# *City of Brisbane*

## *Planning Commission Agenda Report*

**SUBJECT:** **Parking Use Permit UP-1-20 and Grading Review EX-1-20; 130 Sierra Point Road;** R-1 Residential District; Use Permit to allow for nonconforming interior dimensions of a two-car garage and Grading Review for approximately 150 cubic yards of soil cut and export to accommodate a new single family dwelling on a 5,000 square-foot lot with a 33% slope; Wilson Yu, applicant and owner.

### **SUPPLEMENTAL REPORT**

15 EXTERIOR ELEVATION - WEST

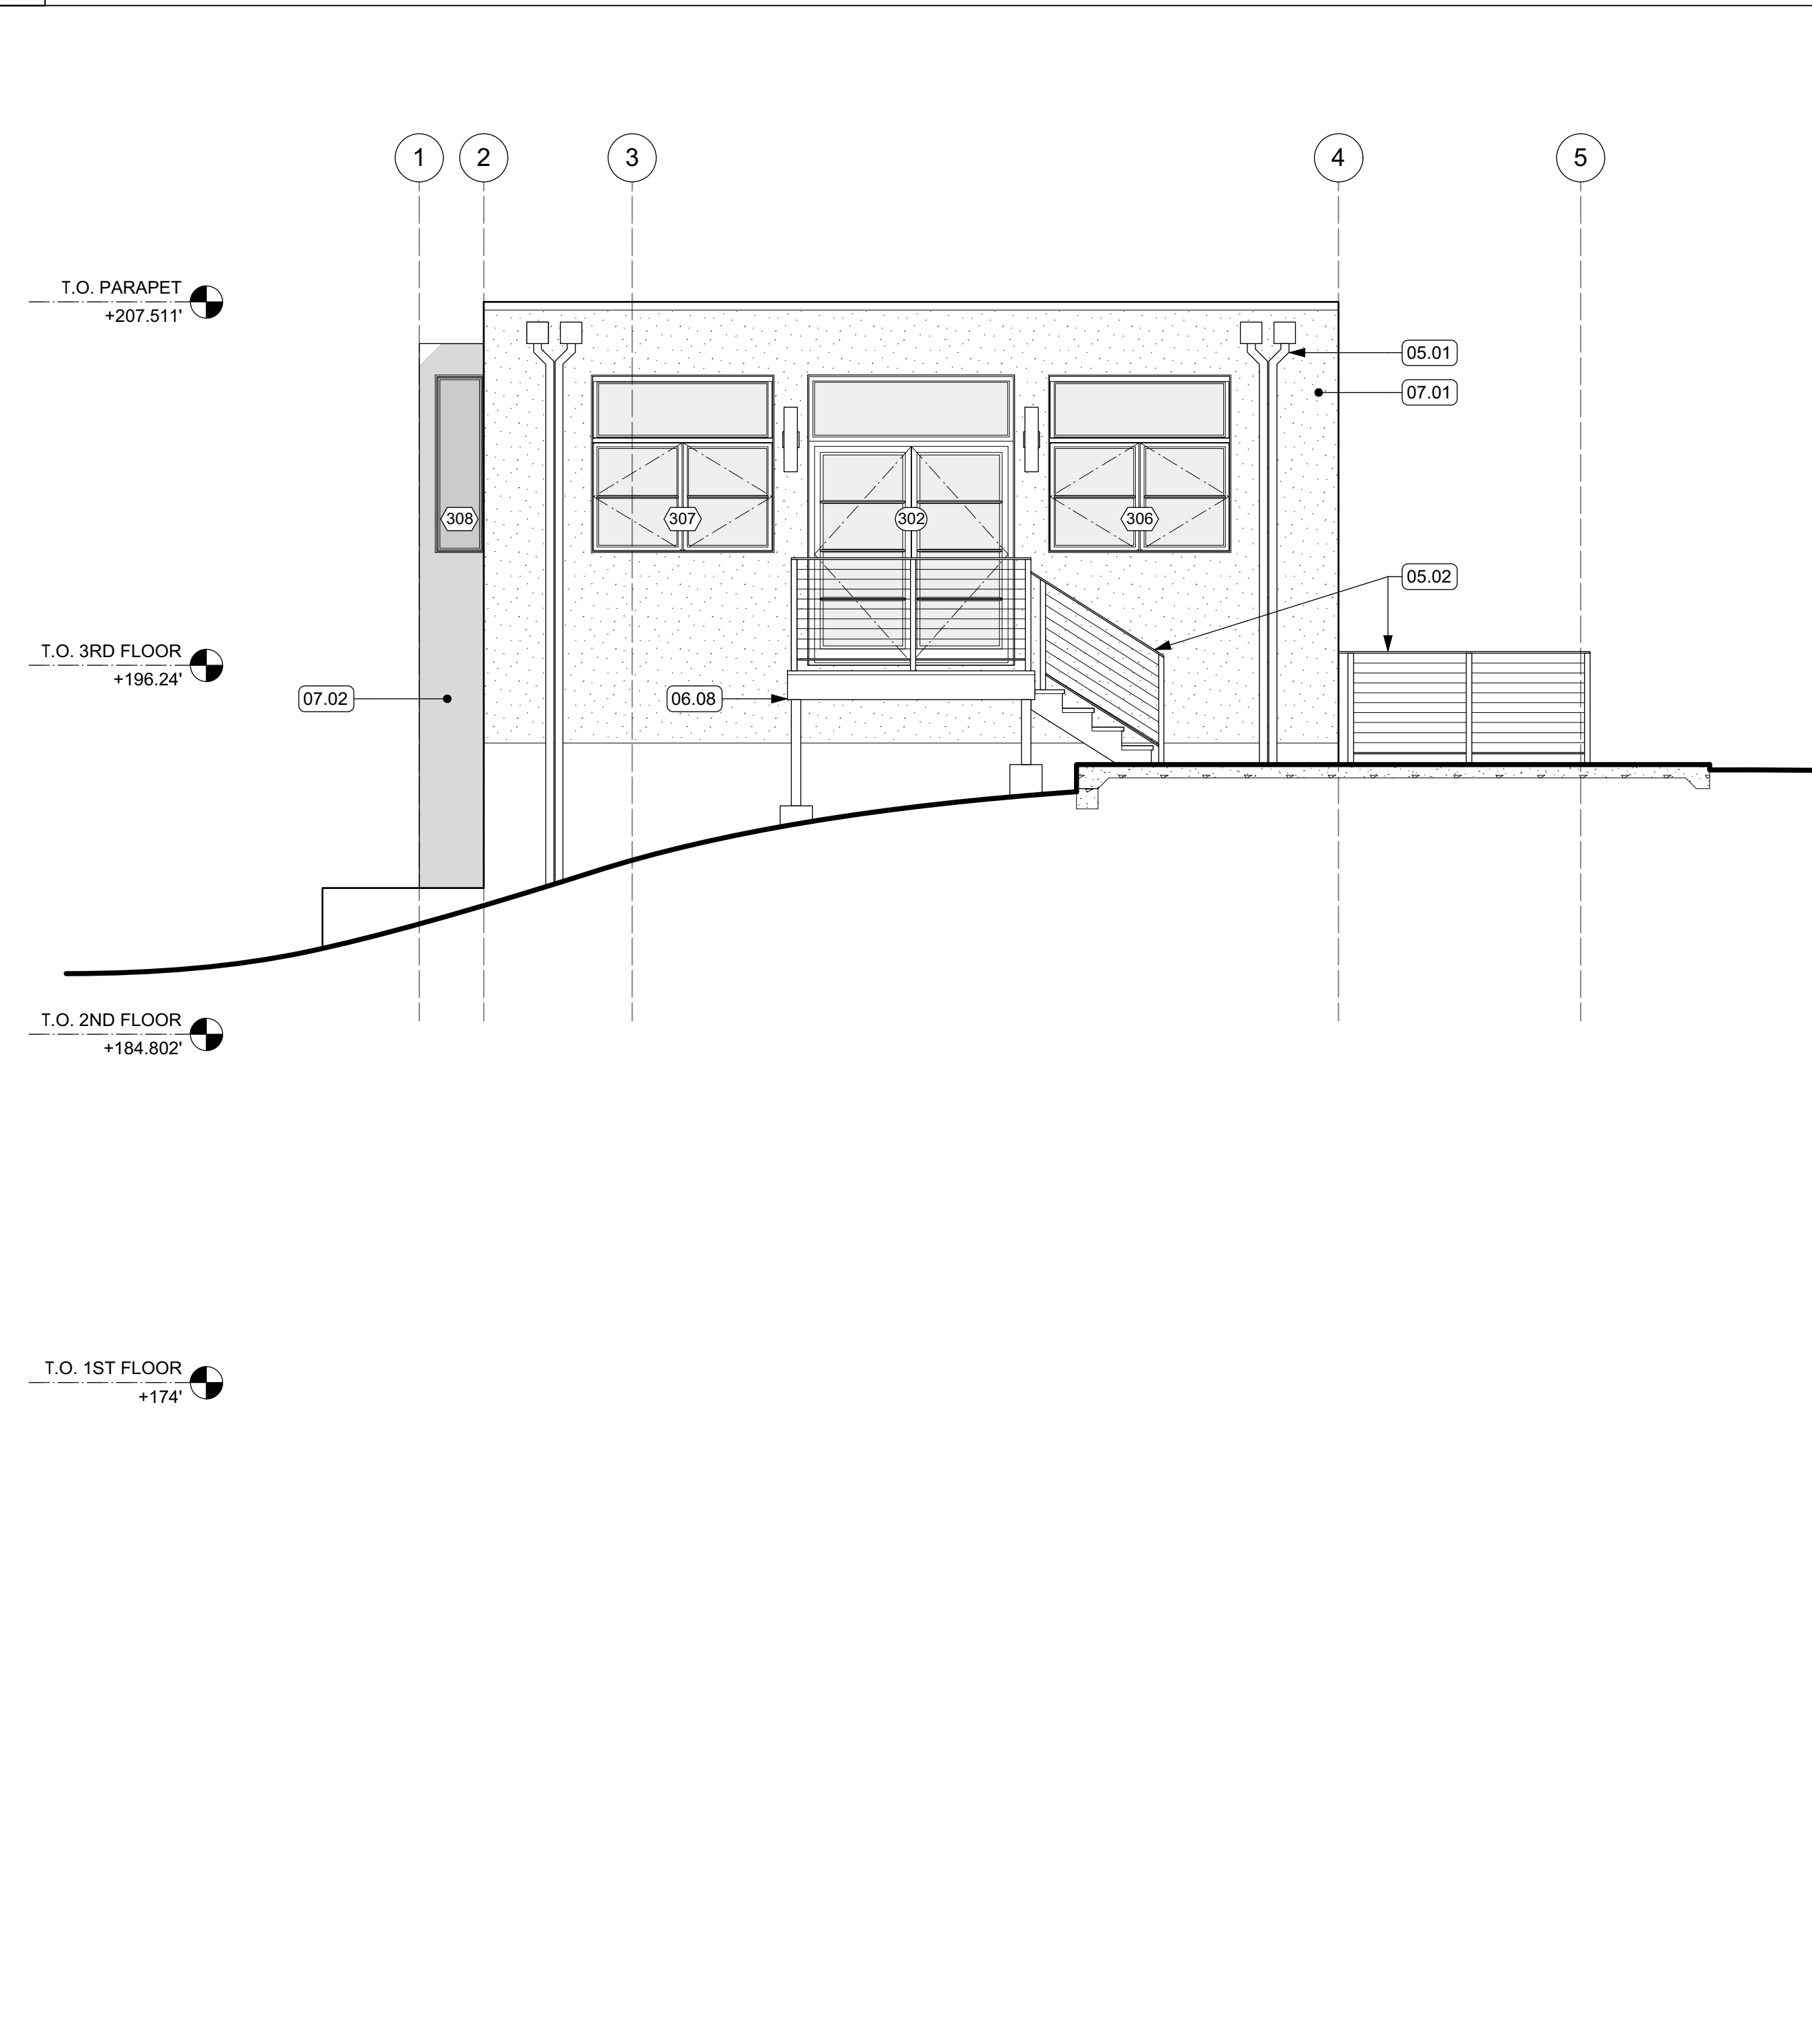
Large, exposed retaining walls are avoided or not visible from the street. BMC §17.32.050 permits retaining walls less than six feet in height within any setback area. Walls that exceed six feet in height in a setback area require vegetative screening or wall treatments to break up the massing of the wall. A proposed 4' 6" retaining wall along the front lot line will accommodate the required on-street parking (see sheet A202 of the applicant's plans, Attachment E.i).
